AGENDA
PLANNING AND ZONING COMMISSION MEETING
CITY OF CREVE COEUR, MISSOURI
MONDAY, JUNE 1, 2020

1. PUBLIC HEARING. Application #20-002 & #20-010: Boundary Adjustment, Site Development Plan and Conditional Use Permit for QuikTrip Gas Station with Convenience Store at 11004, 11026, and 11032 Olive Boulevard and 825 and 827 Graeser Road, and the Redevelopment of the Adjacent Retail Center at 11032 and 11056 Olive Boulevard

**APPLICATION TO PLANNING AND ZONING COMMISSION
#20-002 & #20-010: BOUNDARY ADJUSTMENT, SITE DEVELOPMENT
PLAN AND CONDITIONAL USE PERMIT FOR QUIKTRIP GAS STATION
WITH CONVENIENCE STORE AT 11004, 11026, AND 11032 OLIVE
BOULEVARD AND 825 AND 827 GRAESER ROAD, AND THE
REDEVELOPMENT OF THE ADJACENT RETAIL CENTER
AT 11032 AND 11056 OLIVE BOULEVARD**

REPORT PREPARED BY: Whitney Kelly, AICP, City Planner
DATE: 5/26/2020
ATTACHMENTS: Applicant's Revised Materials received May 11, 2020
MoDOT Comments
City's Traffic Engineers, GBA, Response Letter
CBB response to comments dated May 26, 2020 and May 28, 2020
Letter from Graeser Neighbors received May 20, 2020
Comments received by May 28, 2020

Figure 7: Close-up of the North Elevation

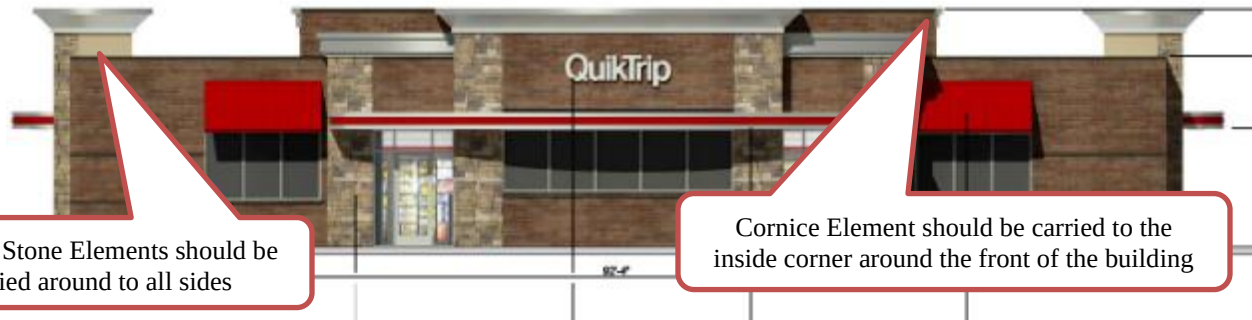
- *Building elements, such as parapet wall, penthouses or screen walls should be treated as an integral part of the architecture, and that material and color changes should occur at a change of plane.* The mechanical screening and parapet walls are well-integrated on the C-store that utilized the same brick material as the building. However, the stacked stone materials are not carried all the way around on the east and west tower elevations, and the metal coping around the mechanical screening should be carried to the inside edge around the front of the store.

Figure 9: Close-up of the rear elevation of the retail center

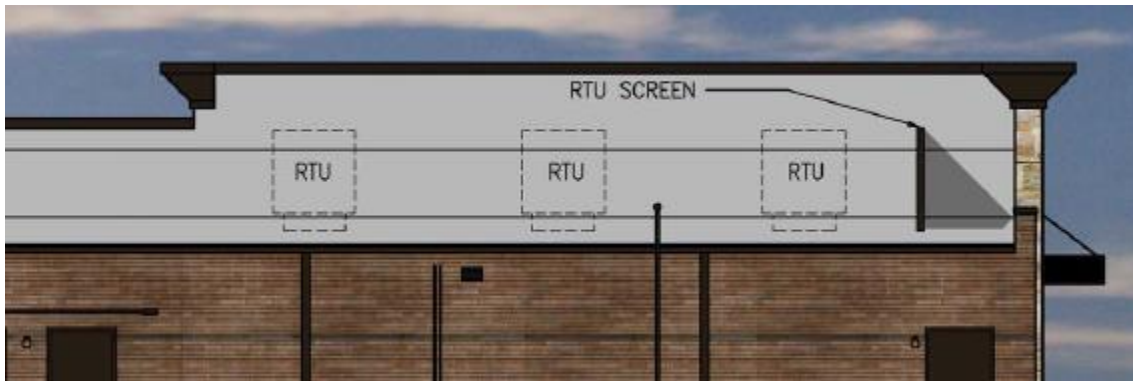
Staff is unclear if the rear of the building provides for roof-top screening, with the two lines not identified, and the mechanical equipment in dashed lines that generally indicate that it is located behind an element.

Figure 10: Close-up of the site plan showing the main entrance.

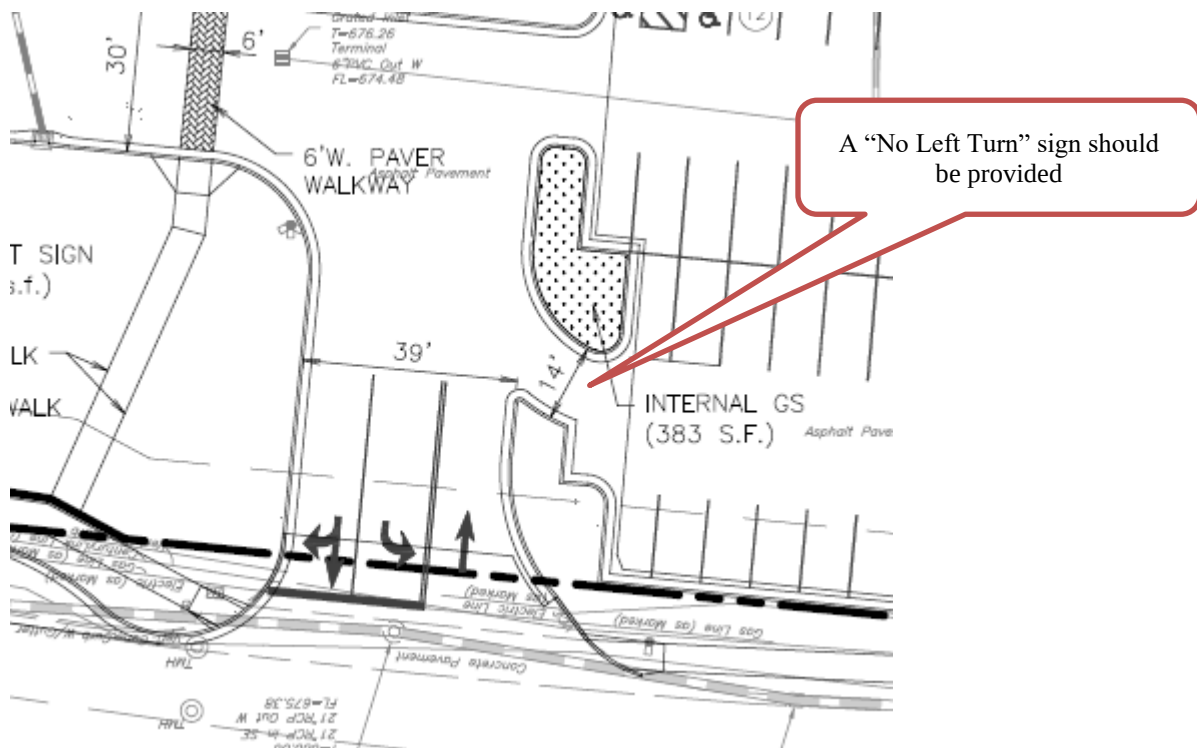
- Access to all service stations should be limited to 2 curb cuts. If at a corner, there should be no more than 1 curb cut per street. Raised planters should be used at various locations to ensure customer safety. The retail center shows the maintenance of the existing entrance that will serve both the gas station and the retail center as a full access. The gas station property is limited to the right in and right out only on Olive, and one access along Graeser Road. MoDOT has concurred with this layout due to the island within Olive Boulevard and the proximity to the intersection. Staff does recommend that a “No Left Turn” will be needed for the parking lot exit. Additional landscaped areas have been provided that are properly curbed within the retail center parking lot, as well as curbed landscape areas for the walkway in front of the C-store. A retaining wall and landscaping are provided between the parking and the new sidewalk along Graeser Road, to comply with these recommendations.

Figure 11: Close-up of the side elevation of the canopy structure

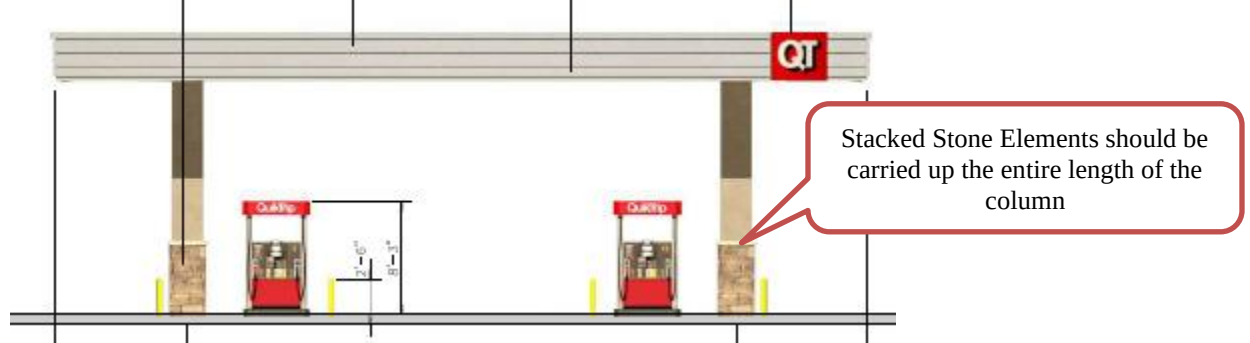
- Separate structures, such as a canopy, car wash, or cashier's booth, on the site should be avoided. When requested and approved separate structures are to have consistent architectural detail and design elements that provide a cohesive project appearance. The Canopy structure does provide similar details as the C-Store and retail building with the use of stacked stone. However, Staff recommends that the stone, or a combination of the stone and

brick to match the building should be carried up the entire length of the column, to better integrate the design with the main building.

Figure 12: Close-up of Landscape Plan along Olive Boulevard.

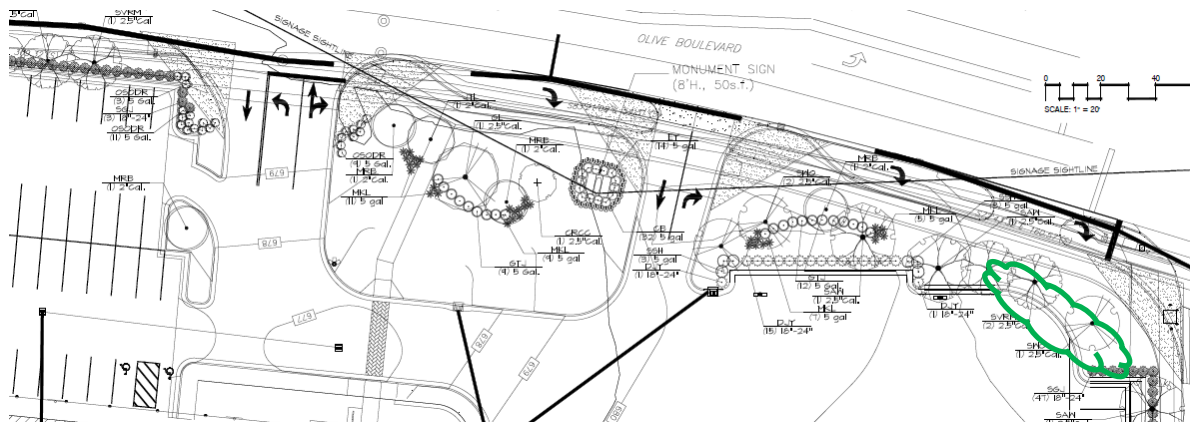
- The Design Guidelines strongly encourage high quality landscaping that accentuates the building and site, softens the effects of parking in areas and enhances the quality of life of the City; and, that there is a consistency of landscape design throughout a development, and that landscaped areas are to be maximized and balanced throughout the site. Further, the Comprehensive Plan recommends that when parking is located in front of the building breaking up parking and provide a buffer zone between parking and buildings. Additionally, the Comprehensive Plan calls for well landscaped frontages along Olive Boulevard. The Landscape Plan shows the new landscaping for both the retail building and the gas station, with the appropriate number of street trees and a landscaped hedge. However, Staff would like to see greater layering with additional plantings at the corner along the retaining wall. The hedge along the front of the existing parking of the retail building are within MoDOT right-of-way, and therefore a maintenance and use agreement for this area will be required by MoDOT. Further, the Code requires that all trees are to be a minimum of 3-inch caliper size providing clear headroom of at least six (6) feet, per Section 405.540(F)(1) of the Landscape regulations, where the plans show a caliper of 2.5”.

Figure 13: Close up of the Landscape Plan of the areas in front of the buildings.

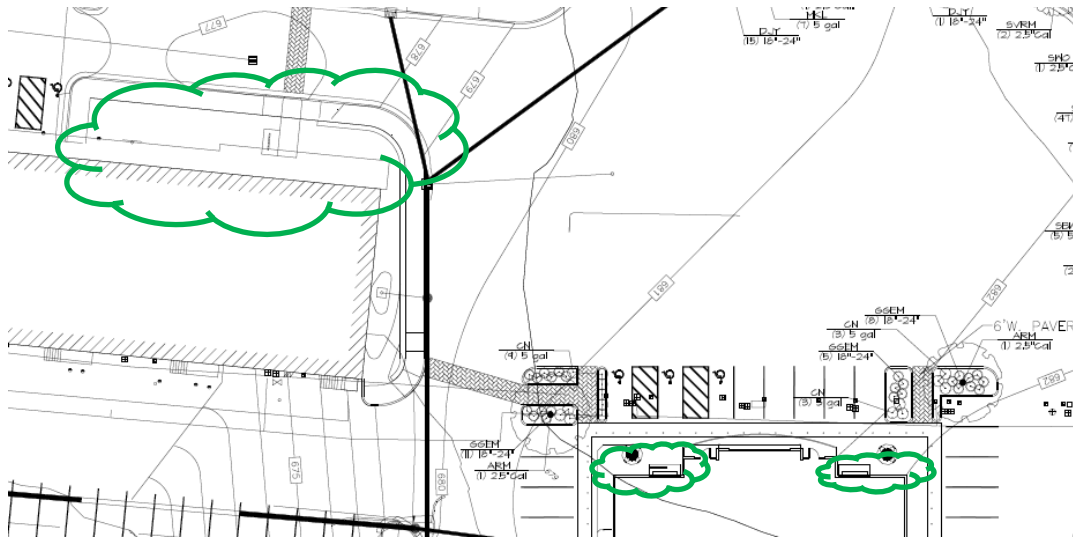
The renderings and site plan show landscaping adjacent to the building to break up the hard surfaces of the outdoor seating, and the building in order to meet with the recommendation with the recommendations. However, the landscape plan is not showing plantings in these areas. Consistency between the Landscape Plan, the Site Development Plans is needed and landscaping adjacent to the buildings should be provided, particularly where the new landscaped patio area in front of Pumpnickels at the retail center. The Applicants have indicated that the new patio area for the retail center has not been fully designed as they would work with the tenants to determine the landscaping in conjunction with the allowance for outdoor seating. If the Commission feels that this is sufficient, staff can work with the Applicant to further refine this area as a condition of approval.

Figure 15: Close-up of the rear of the development on the area formerly 825 & 827 Olive Boulevard

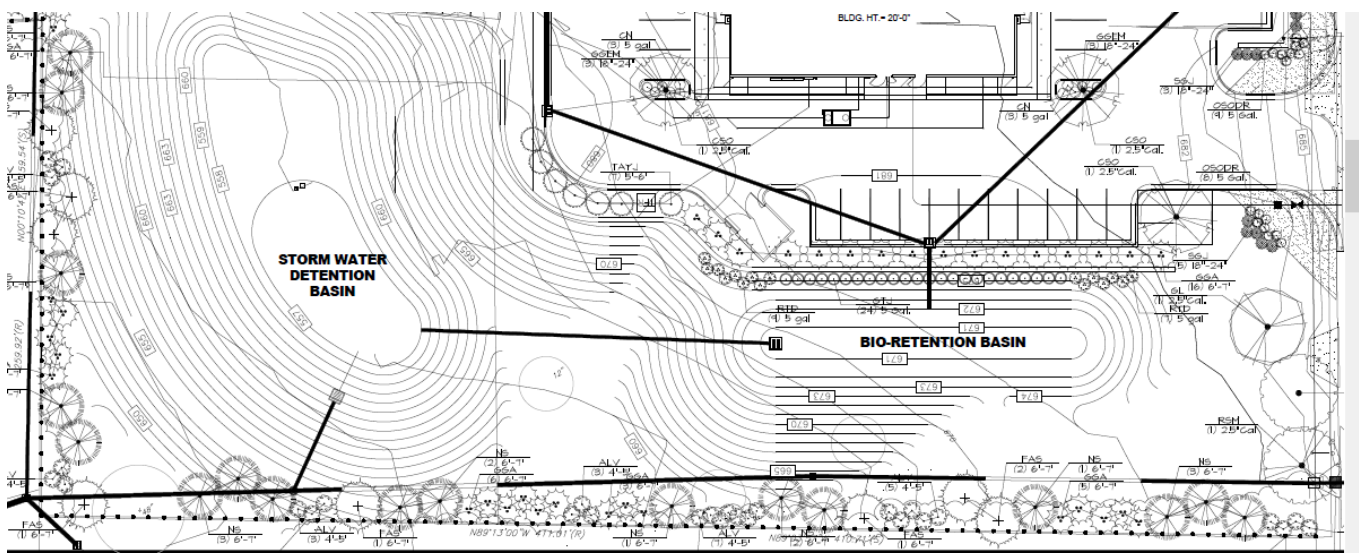
The rear landscaping provides significant evergreens to provide year-round screening along the property lines in addition to the 8-foot tall wood shadowbox fence. Additional landscaping is

proposed along the base and on top of the retaining wall along the back of the building and parking area, in compliance with the City's Design Guidelines that recommend minimizing the height and length of the retaining walls and screen with appropriate landscaping. Additionally, retaining walls in excess of 4-feet in height should be terraced with planting area terrace separation between levels, and materials utilized for the retaining wall should match the primary building materials. With respect to the fence, the Commission should determine if it should be placed at the property line as shown, or interior to the site with the evergreens placed on both sides, so that the residents benefit from the landscaping.

Figure 16: Close-up of the site plan showing sidewalks in front of the store.

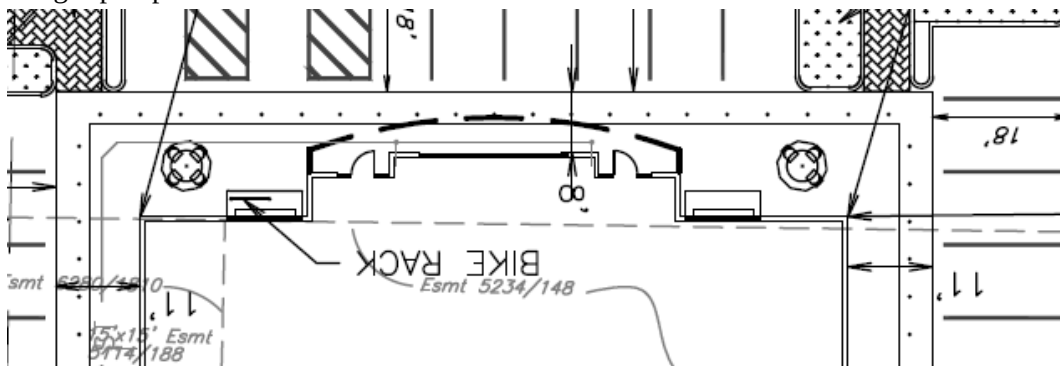
- *The Design Guidelines recommend that sidewalks in front of retail businesses in a commercial district should be a minimum of 10 feet and include pedestrian amenities such as planters and benches. Outdoor sales, dining or storage should not impair pedestrian movement, and should maintain a minimum 4-foot clearance path along the sidewalk. Section 405.730(A)(2) Sidewalks of the Zoning Ordinance requires a minimum width of internal sidewalks in non-residential developments to be at least six feet and eight if used as a curb stop discussed further below. The Applicant is showing 8-feet along the front of the central tower element, and eleven feet along the east and west sides of the building. Table seating and a bike rack are provided along the front elevation, per the image below. However, the drawings show low bollards within this area, therefore staff recommends a condition of approval that at least six feet of clear access be maintained between the bollards and the building entrances, to comply with the requirements of the Zoning Ordinance and the Design Guidelines. The front elevations are also broken up with pedestrian elements and landscaping including access for those walking to the front doors from the gas pumps.*

Figure 17: Close-up of the Site Plan showing new detached sidewalks along Graeser Road on right and Olive Boulevard on left

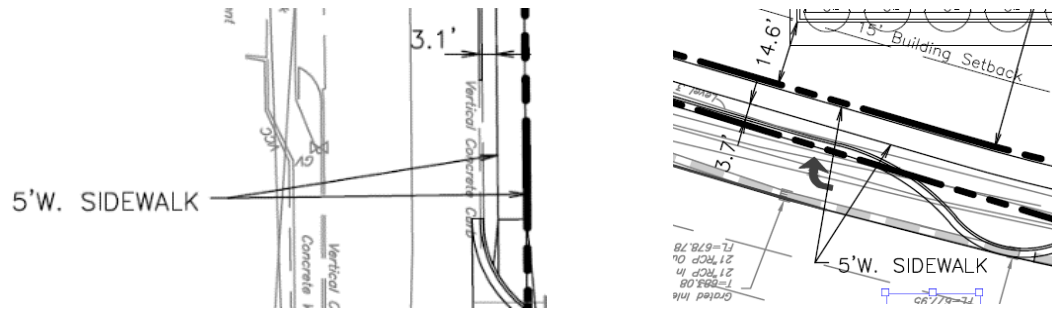
- The Applicant is showing that all pedestrian crosswalks will utilize a stamped textured concrete in furtherance of the Design Guidelines that recommends at intersections, crosswalks, and main building entries, a change in sidewalk color, texture, or material should emphasize the location. Paint Striping to accentuate these areas is strongly discouraged. (p. 5). And is required in Section 405.730(A)(1)(c) Sidewalks of the Zoning Ordinance.
- The City's Pedestrian Plan indicates that Olive Boulevard as a primary street should have a separated sidewalk, as well as provide for a separated sidewalk along Graeser that are 5 feet in width. The Applicants are providing for new separated sidewalks along both Olive and Graeser Roads. The Graeser Road sidewalk is within the existing right-of-way, and therefore will not require an easement to the City.

Figure 18: Close-up of the Site Plan showing buffer area

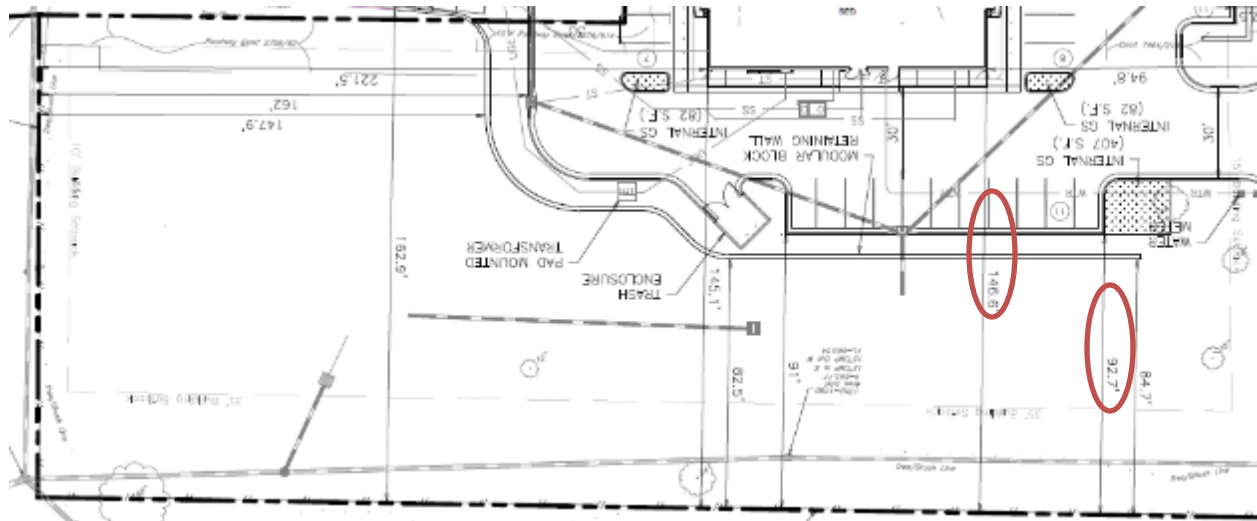
and provided with other screening devices as deemed appropriate by the Planning and Zoning Commission. As discussed above, the proposal will consolidate the non-conforming six parcels into one 2.54 acre parcel (+0.06 acres dedicated for right-of-way) for the gas station lot; and the remaining portion of 11032, and 11056 Olive Boulevard into one 1.82 acre parcel (+0.01 acres dedicated for right-of-way) for the existing retail building, with significant buffering that exceeds the required minimum buffer of 25 feet, where almost 93 feet of landscaping from the rear parking to the nearest residential property line.

Figure 20: Close-up of the "Demo" Plan and the Site Plan of the two parking spaces that will have to be removed and the existing green area to remain.

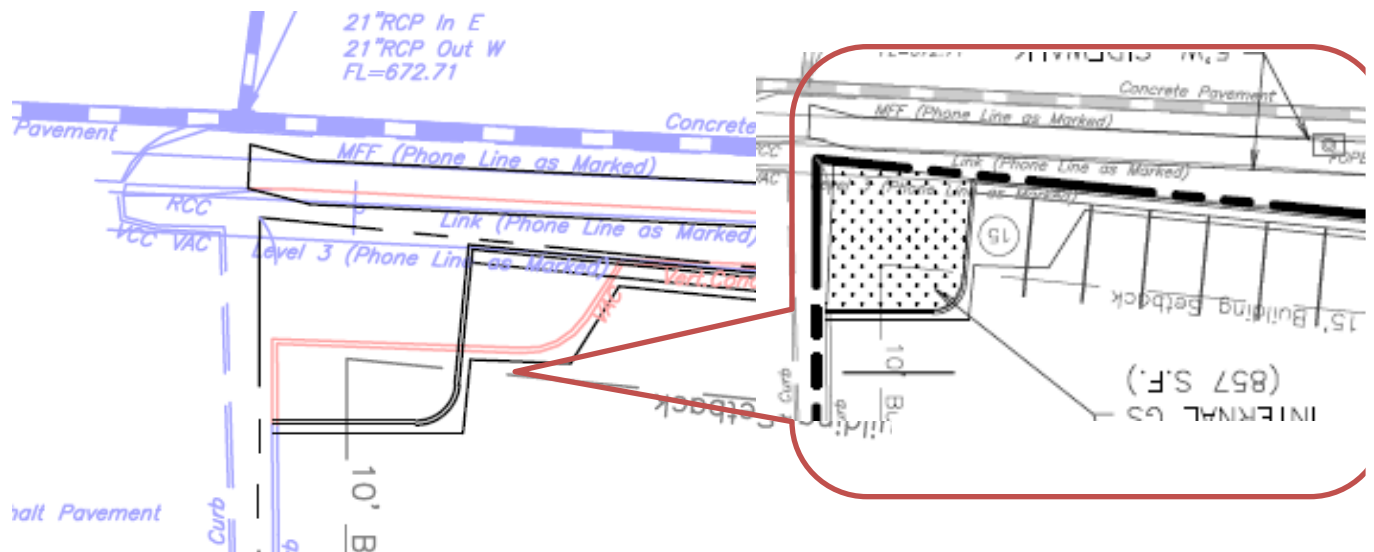
The site data table on the drawings is showing incorrect information. Below are the corrected site data table for each of the properties. The table also includes the reduction of the retail center parking to be 84 spaces. The existing parking along Olive Boulevard is pre-existing non-conforming, in that they are placed at the property line, where the current regulations require a minimum of 10 feet of landscaping and/or pedestrian facilities, per Section 405.240(B)(2) of the Zoning Ordinance. The site development plans showed an addition of two parking spaces in line with the existing parking at the northwest corner of the site, where there is currently landscaping. Therefore, the parking spaces on the drawings will have to be removed as it would be increasing the number of parking within the setback.

- “Demo” Plan seems to be a mislabeled, as it is showing existing and proposed development.
- The Site Plan should maintain or enlarge the existing greenspace and remove the two parking spaces proposed at the southwest corner along Olive Boulevard

Figure 21: Close-Up of the Elevations Showing the Trash Enclosure.

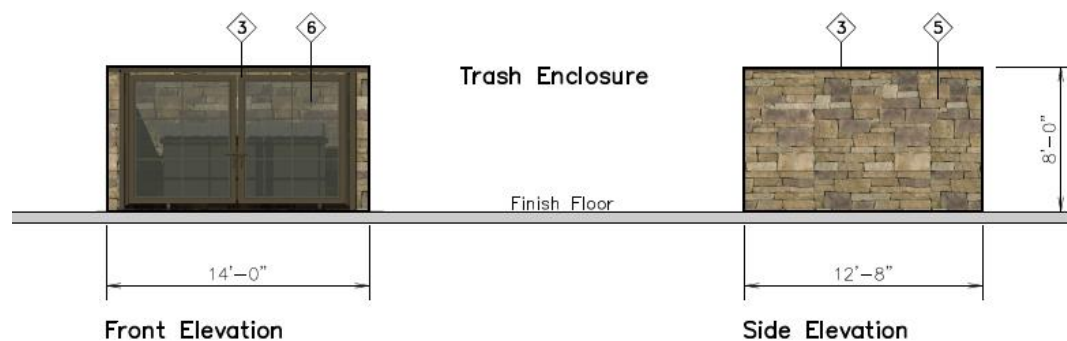
As discussed above, the proposal includes an 8-foot shadow-box wood fence and significant evergreen landscaping at the property line as well as upright evergreen plantings behind the building to screen the retaining wall, and building. The Applicants have indicated that the proposed wood fence is sufficient in consideration of the significant landscaping, as well as over 92 feet between the closest residential property line to the rear parking, and 146.5 feet to the rear of the building, and that a masonry wall is not necessary. Staff is generally in agreement with this, as in other areas where a solid wall was required, these sites were much more open and visible, with not as much landscaping, and the developments were closer to the residential areas. As discussed above, the Commission should discuss with the Applicant whether the fence should be placed at the property line or behind the proposed landscaping, so that the residents get the benefit of the evergreen plantings, and whether or not a masonry wall is needed. The trash enclosure material is a stacked pre-cast stone material that is consistent with the building materials, in compliance with Section 405.470 (A) (13)(g), and located behind the building out of view from Olive Boulevard in compliance with the Design Guidelines that the location of such services should be sited with limited visibility to pedestrians and/or adjacent properties (P.19). However, the final drawings for a permit will require a concrete pad to be provided within and adjacent to the trash enclosure.

Figure 22: Close-up of the Photometric Plan showing lighting levels underneath the Canopy Structure with the highest levels circled in red.

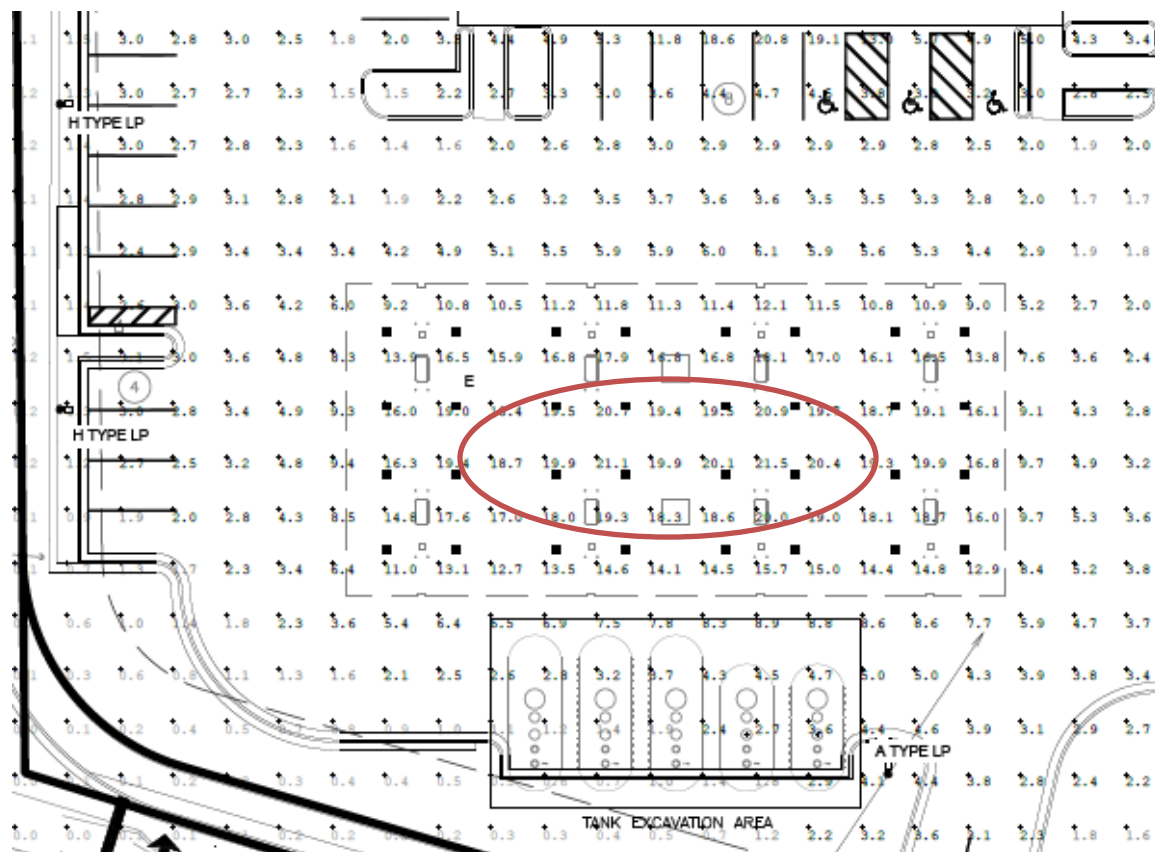
The photometric plan is showing the lighting between the hours of 10:00 P.M. and 6:00 A.M. to comply with the prior requirements. The Photometric plan is showing levels at a maximum of 21.5 underneath the canopy structure, and now light directed outward or onto adjacent property The Applicant has indicated that it will remain at this level during operational hours.
